HI-STAR 100 Certificate of Compliance 9261 HI-STAR 100 License Amendment Request 9261-2

Holtec Project 5014

Holtec International herewith submits License Amendment Request (LAR) 9261-2 proposing certain changes to HI-STAR 100 System 10 CFR 71 Certificate of Compliance (CoC) Number 9261, Revision 1 and its supporting Safety Analysis Report (SAR). A summary of the major changes requested in this LAR and the reason for those changes are provided below:

USED IN CONJUNCTION WITH THE APPLICABLE THICH CONTAINS THE APPROPRIATE REVIEWS		
HOLTEC INTERNATIONAL HOLTEC CENTER 555 LINCOLN DRIVE WEST MARLTON, NJ 08053	GENERAL DESCRIPTION HI-STAR 1 OVERPACE	- -	
PROJECT NO. 1020	3913	SHEET 1	TOTAL SHEETS
N/A FILE PATH. G:\D&AMINGS\1020\3913\

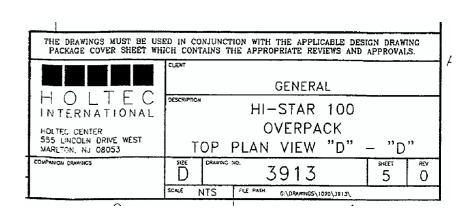
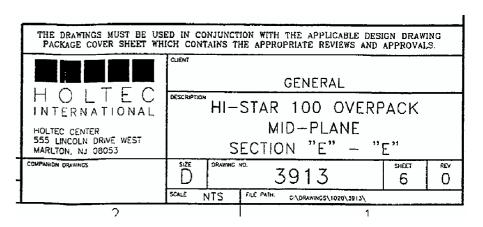
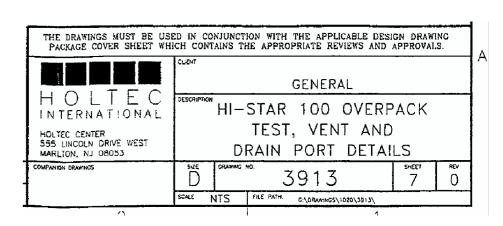
- The locking pads for the overpack lifting trunnions are now designated as optional equipment (Dwg. 3913).
- A provision to modify the lifting trunnion end caps as necessary to permit engagement of the lift yoke links has been added to the overpack drawing (Dwg. 3913).

THIS DRAWING MUST BE USED IN CONTUNCTION WITH THE APPLICABLE DRAWING PACKAGE COVER SHEET WHICH CONTAINS THE APPROPRIATE REVIEWS AND APPROVALS GENERAL MPC-24E/EF **FUEL BASKET** LAYOUT AND WELD DETAILS SCALE NONE G:\DRAWINGS\1022\3925

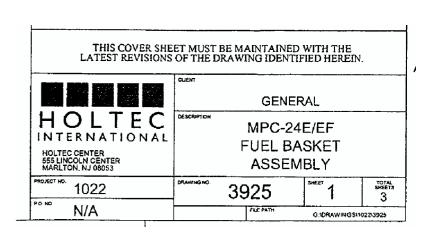
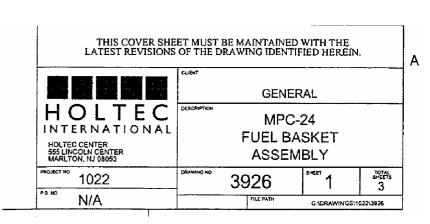
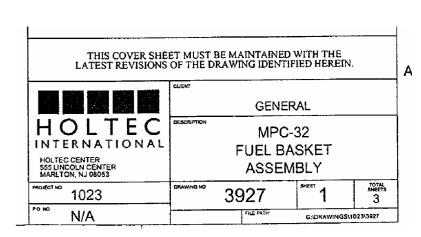
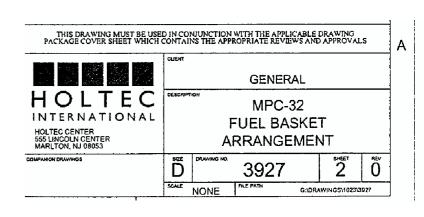
- Notes have been added to the MPC-68/68F/68FF and MPC-24E/24EF fuel basket drawings (Dwgs. 3925 and 3926) to allow limited defects in the Boral neutron absorber, which have been previously analyzed and found to be acceptable as one-time fabrication deviations. Note that these allowances are only for deviations occurring in the MPC fabrication shop and would not be acceptable in material received from the Boral supplier.
